# **DRAINAGE LETTER REPORT**

**NOR'WOOD BIBLE CHURCH  
LOT 38, SADDLEHORN RANCH FILING NO. 3**

October 13, 2023  
Revised January 15, 2024  
Revised May 9, 2024

**JPS Project No. 042303  
PCD Filing No. PPR2346**

## Culvert CH2 (Q5=2.81 cfs, Q100=9.05 cfs)

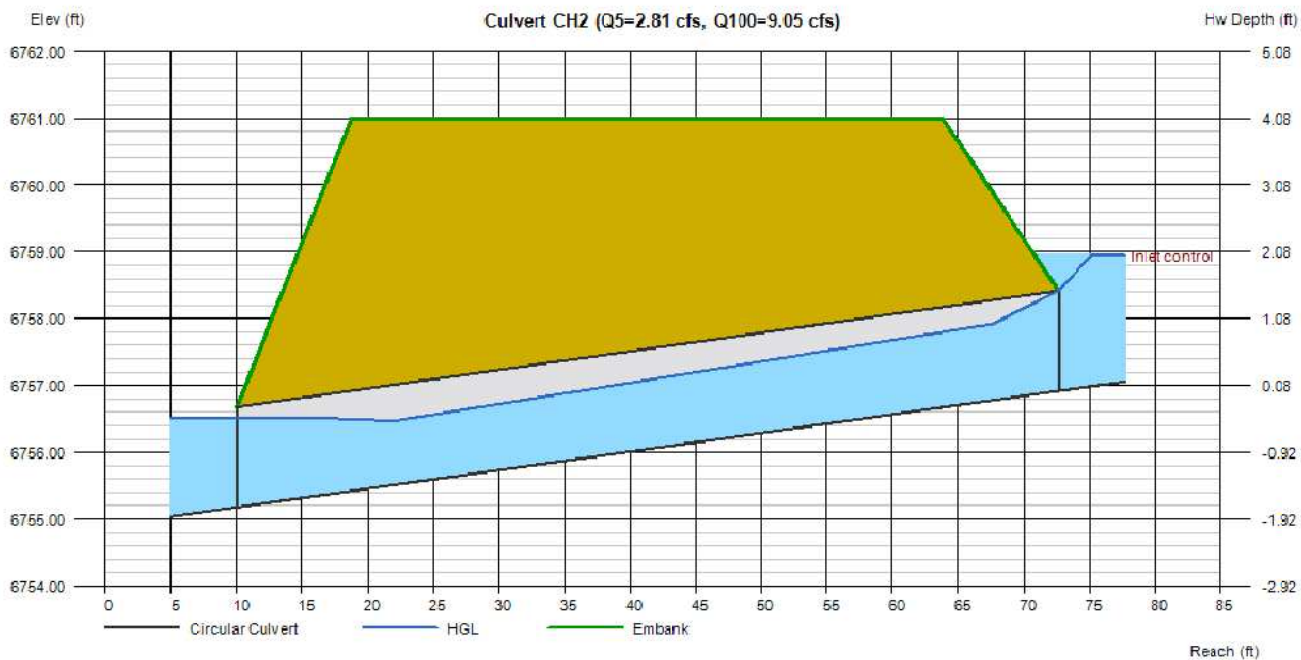
This culvert will be constructed by a different contractor alongside construction of the church site. The estimated flow being captured by this culvert is estimated to be 67% of the flow generated by Basin D1. This flow estimate is larger than what will actually flow to this culvert given where the culvert is placed in relation to the basin.

SADDLEHORN RANCH-FILING 3  
PROPOSED DRAINAGE MAP  
JOB NO. 25142.05  
6/16/23  
SHEET 1 OF 4

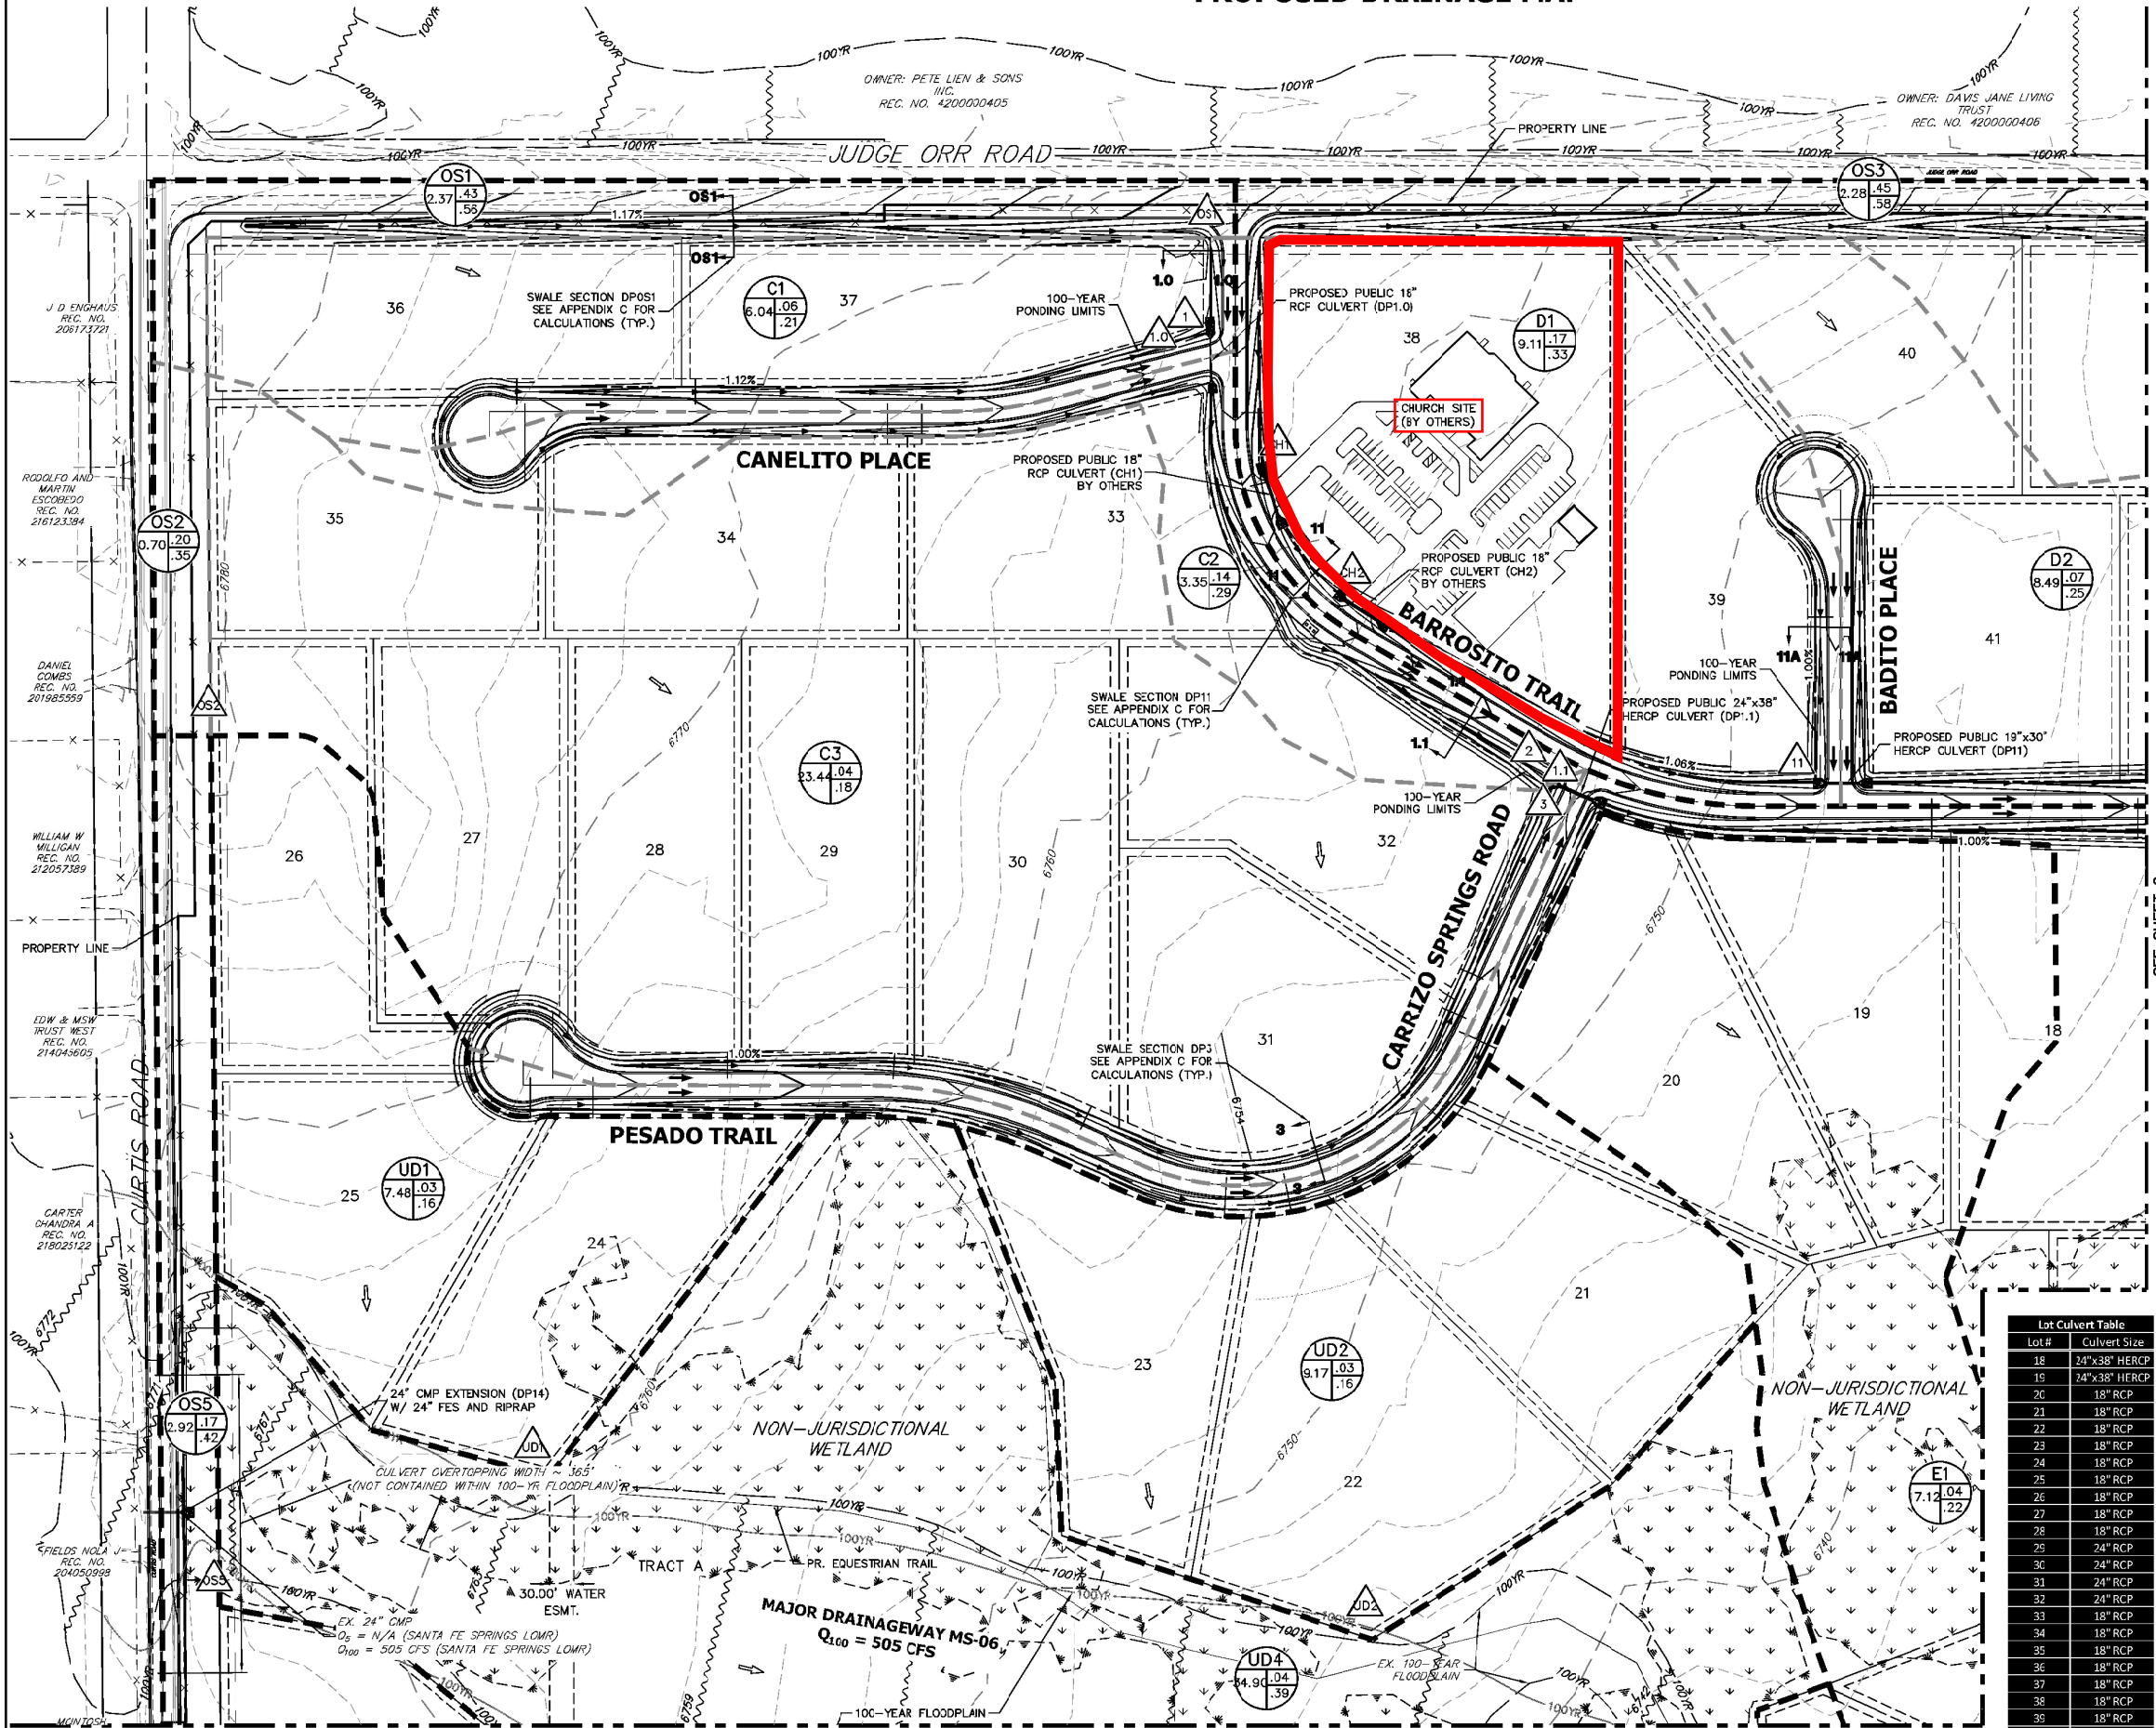
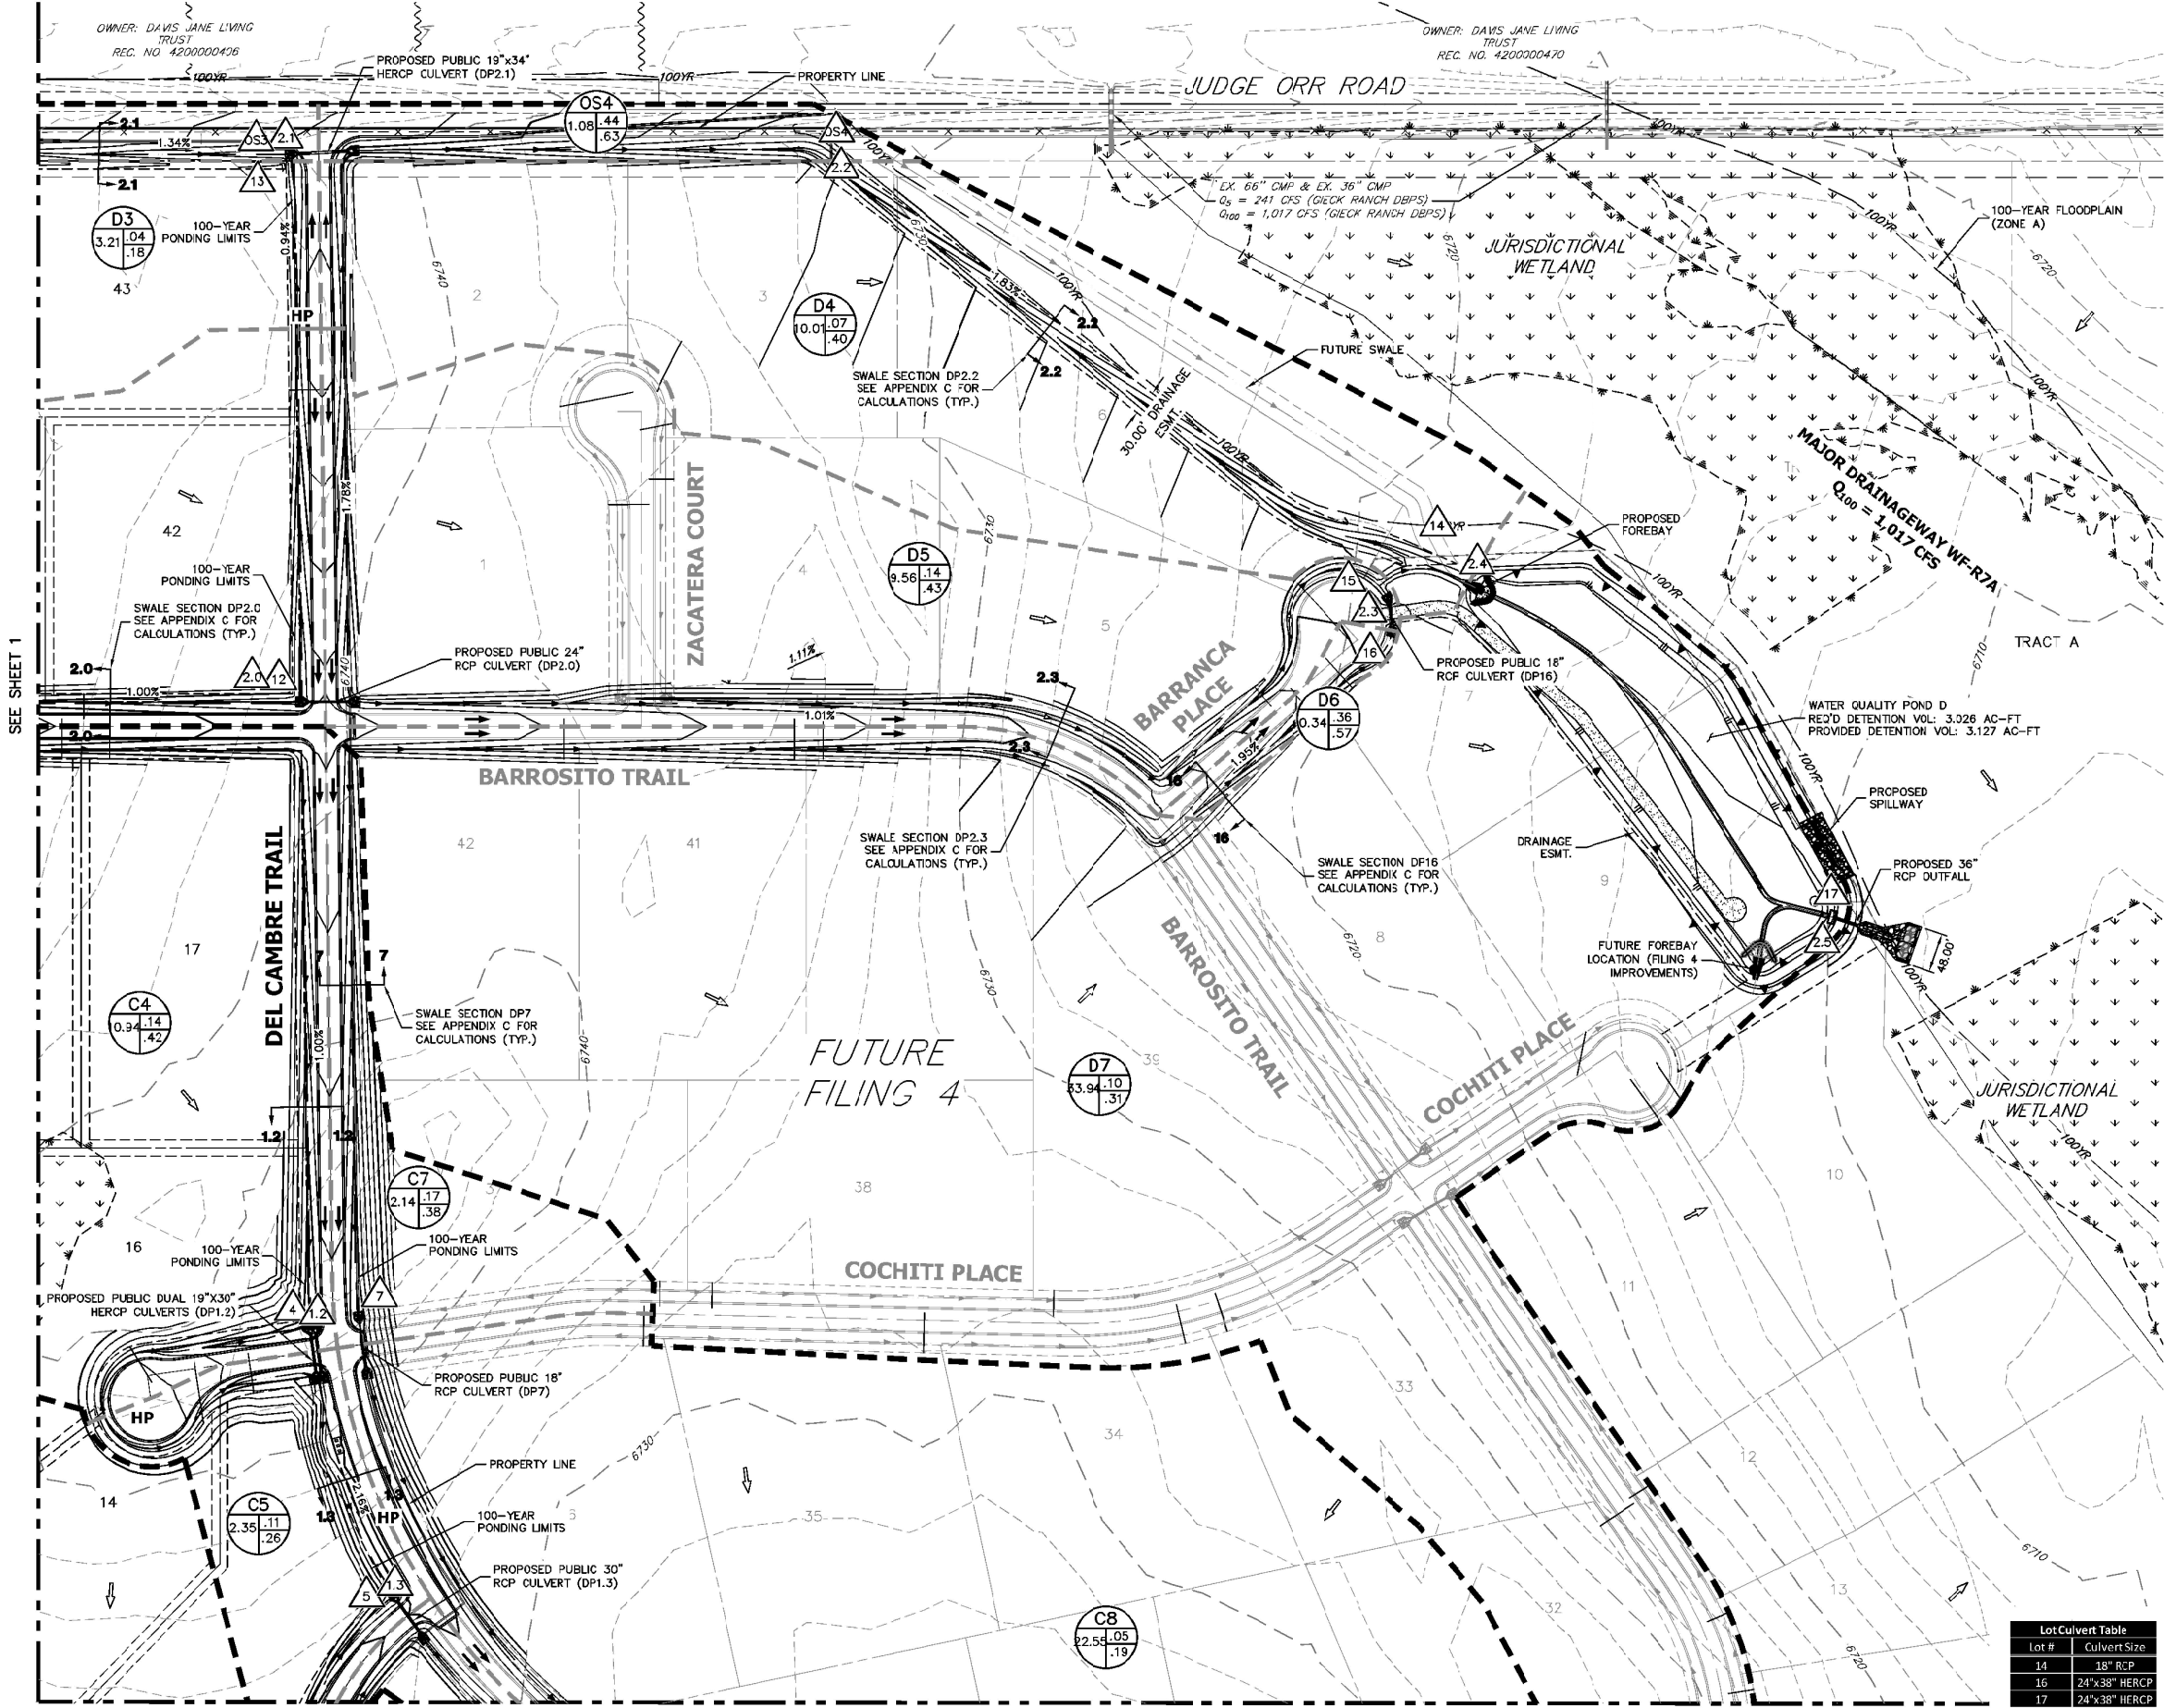
Where did calculations come from? It appears that these calculations were not included in the SF234. Please update the excerpt once the SF234 gets approved.

Review C1: Need to include  
portion of spreadsheets which  
calculate flows.  
Review C2: Unresolved  
Review C3: Unresolved
